ADDENDUM NO. 2

DATE: February 24, 2023

RE: Dickinson Park Sports Fields Renovations
Project No.: 21-1558

Drawings: (all revisions have been clouded and tagged with a delta-2)

SHEET TITLE: STRUCTURAL DETAILS

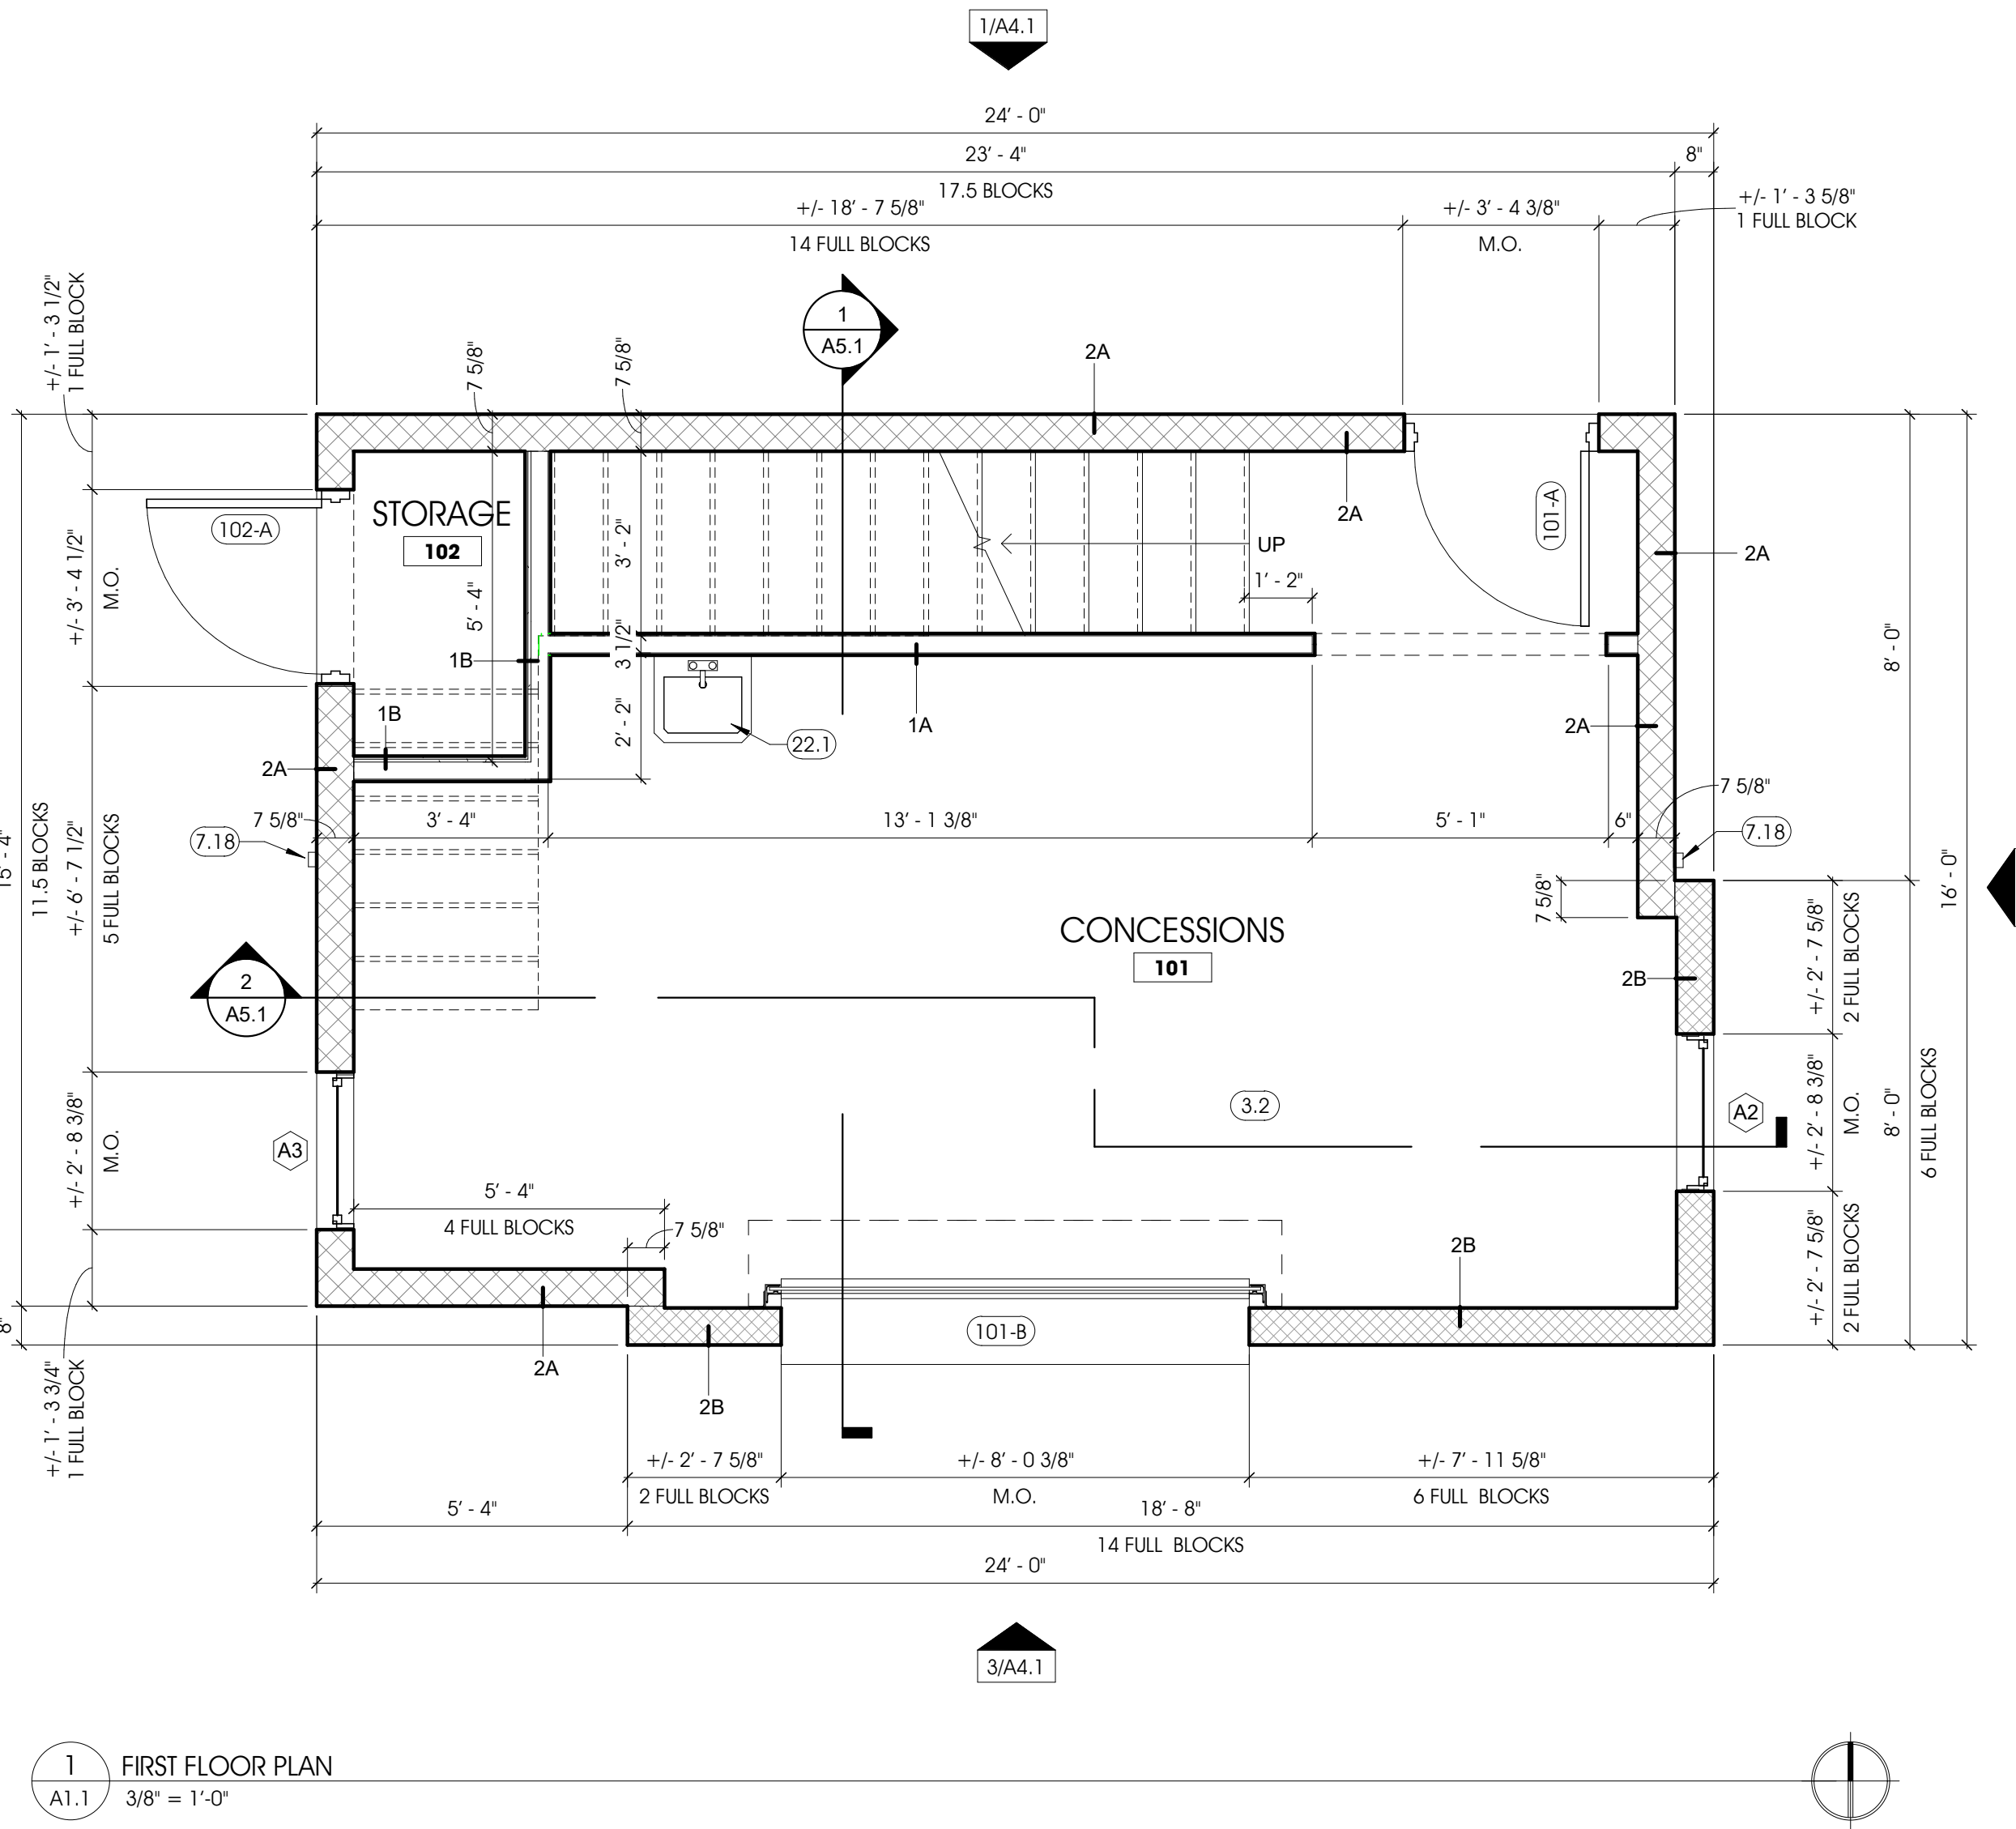
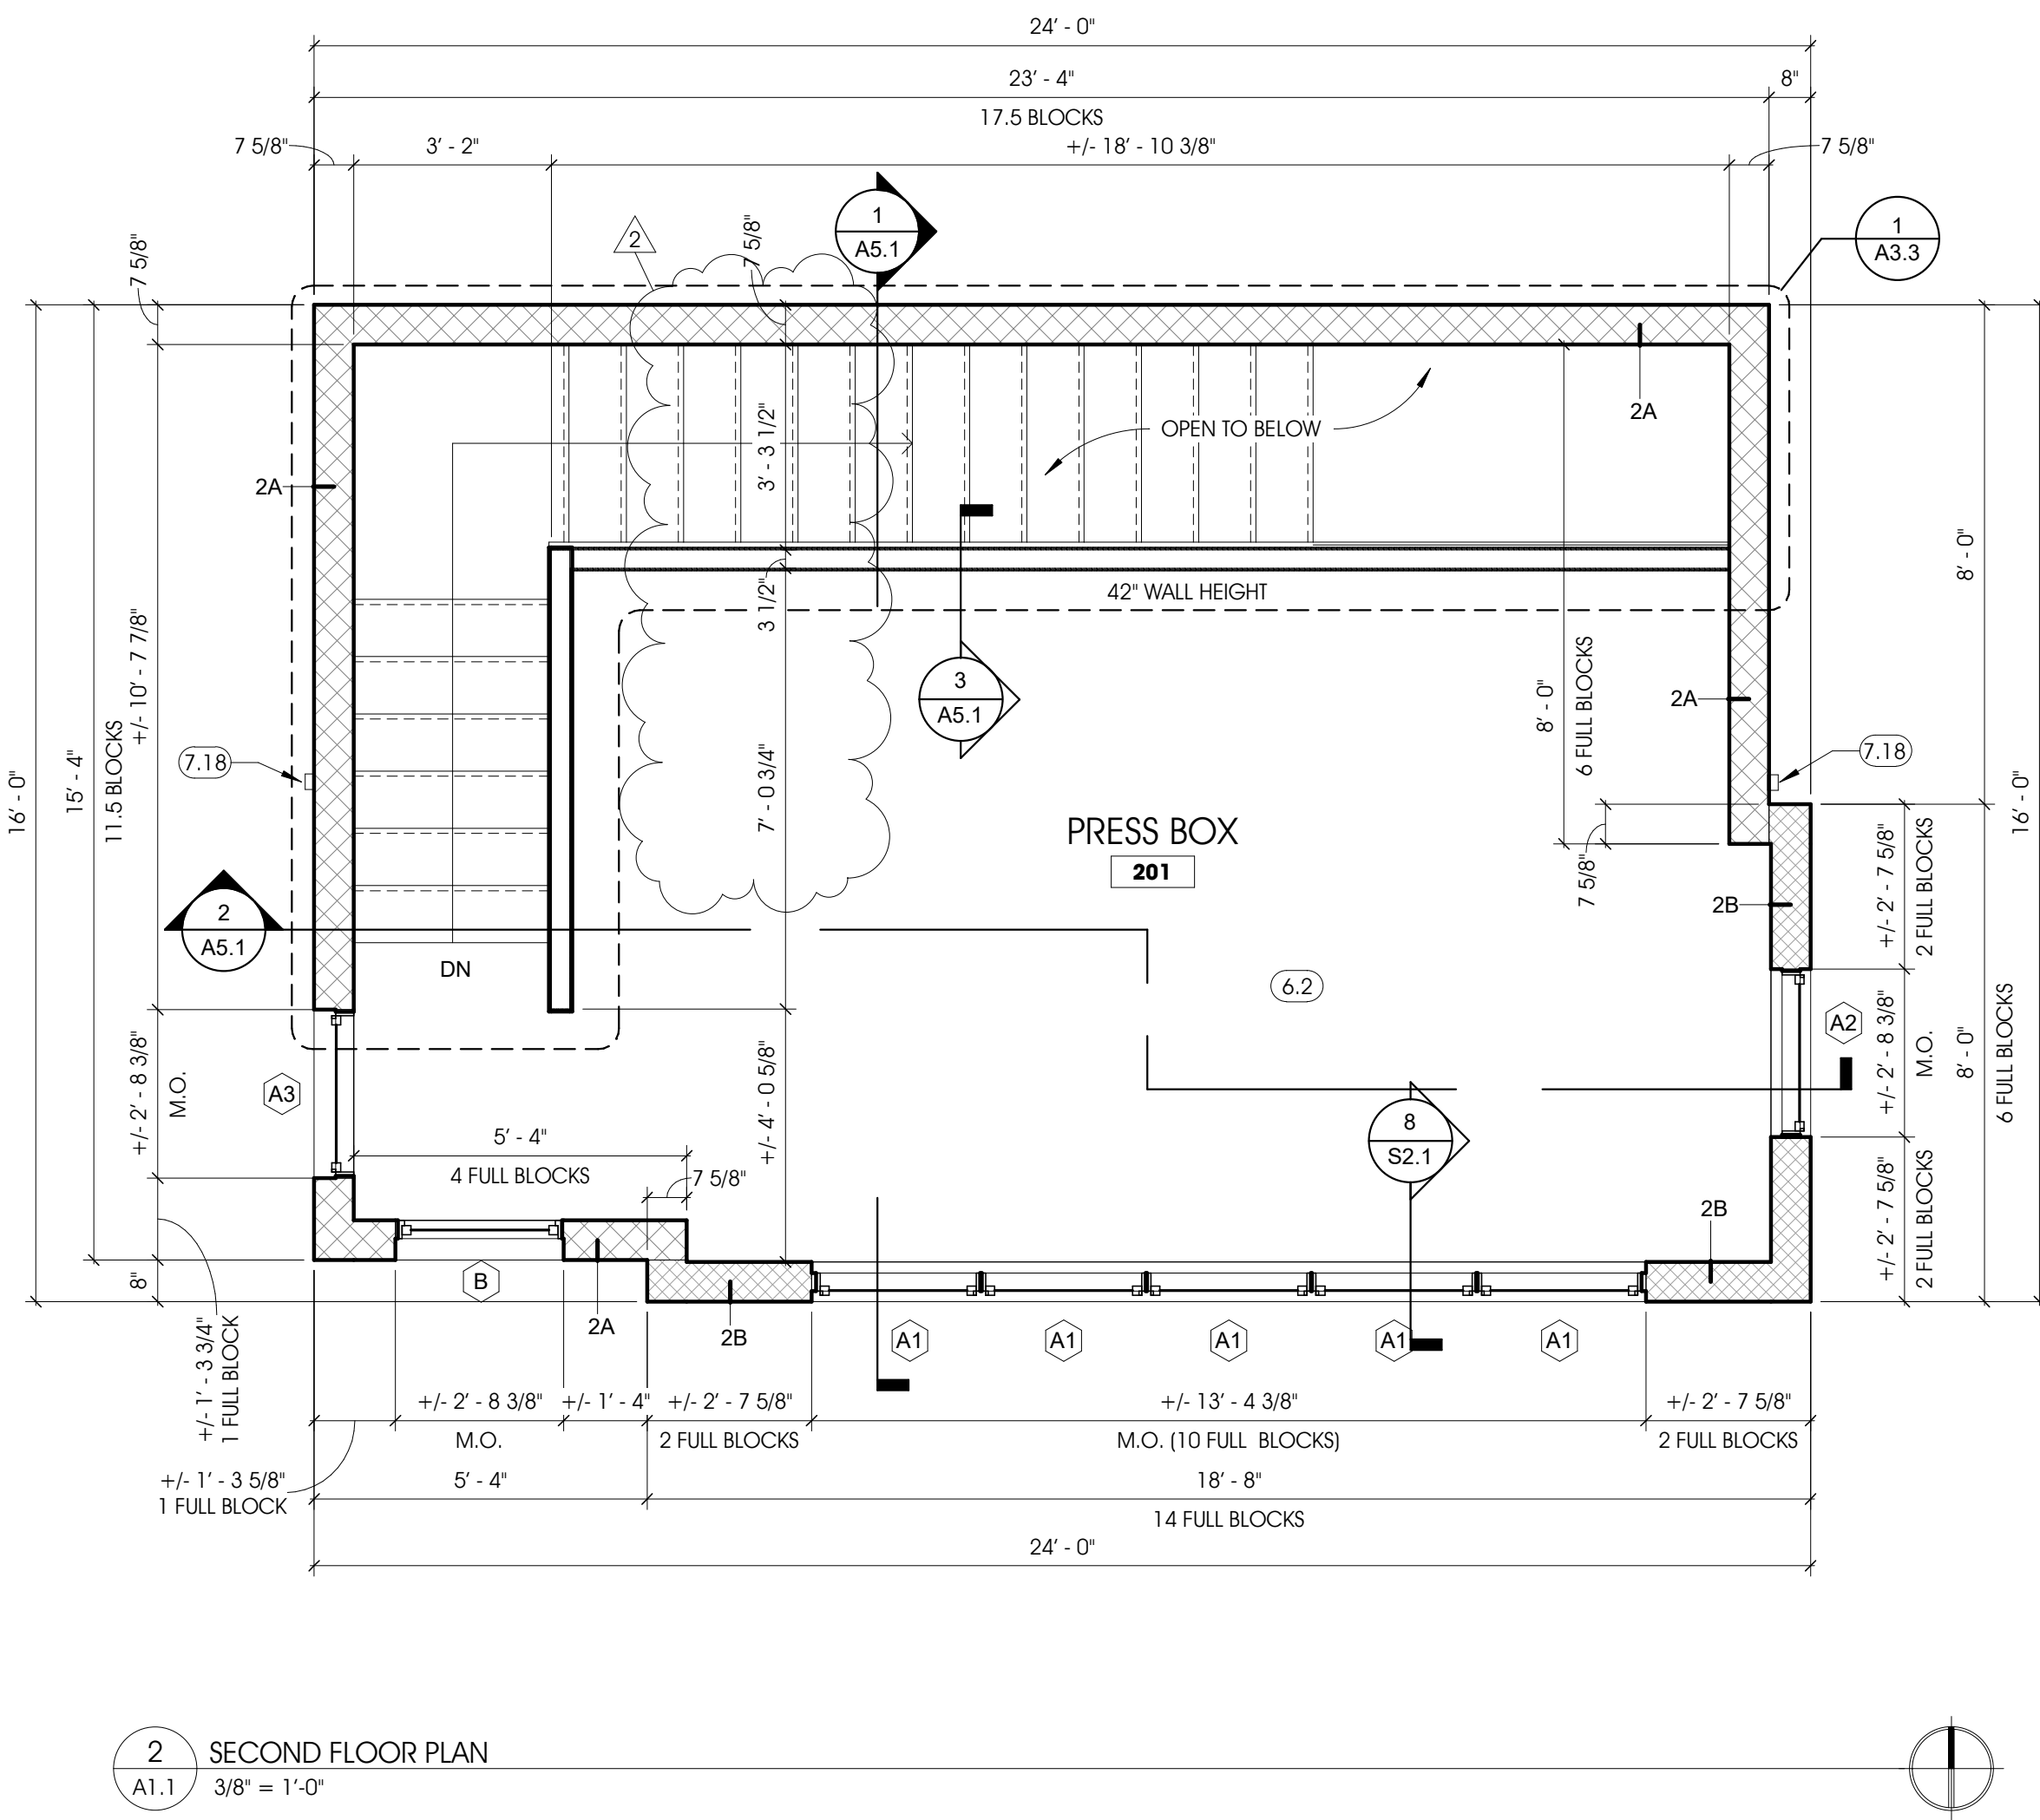
- d. Added Lintel Sections detail drawings.
 - e. Minor revisions to General Notes C and F.
13. Alternate 1, Sheet S2.1
- a. Added Sheet S2.1; previously omitted by error

- b. Added top of CUM Wall, Roof Rafter tie-down/anchoring details (drawings 2/S2.1, 3/S2.1, 5/S2.1, 6/S2.1)
 - c. Added Ledger Detail (drawing 8/S2.1)

- d. Added Detail @ Half-Wall Framing (drawings 9/S2.1 and 10/S2.1)
14. Alternate 1, Sheet A1.1
- a. Revised dimension string in drawing 2/A1.1 (see revision bubble)
